Supplement – OpenBSI 5.9 Service Pack 3

Notes: This supplement documents changes made for OpenBSI 5.9 Service Packs 3. It updates the following manuals:

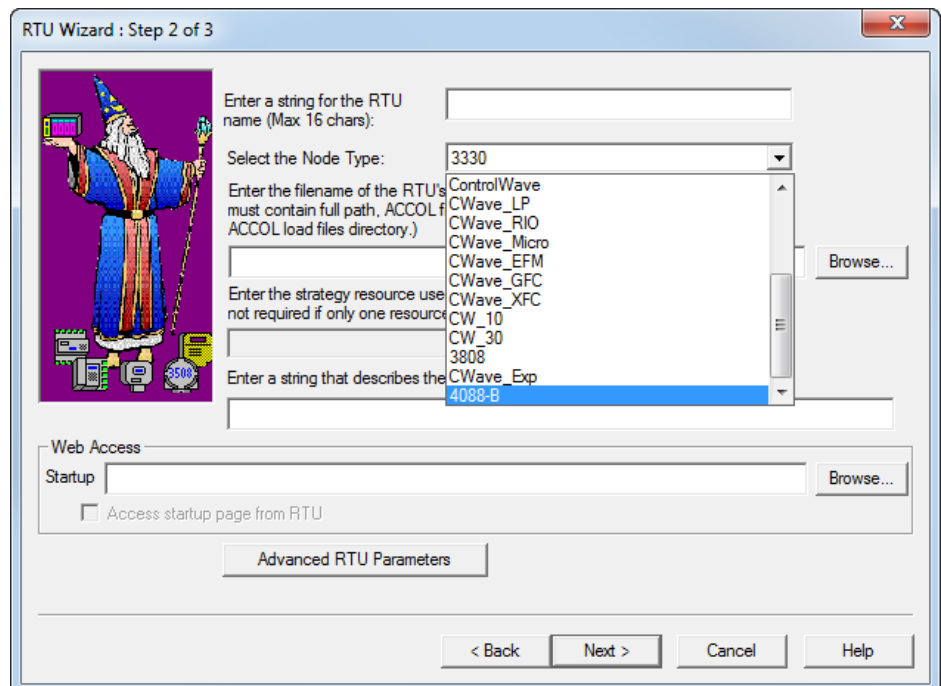
The NetView toolbox has been modified to replace the 3808 icon with a generic “MVT” icon that encompasses both the 4088B and the legacy 3808.
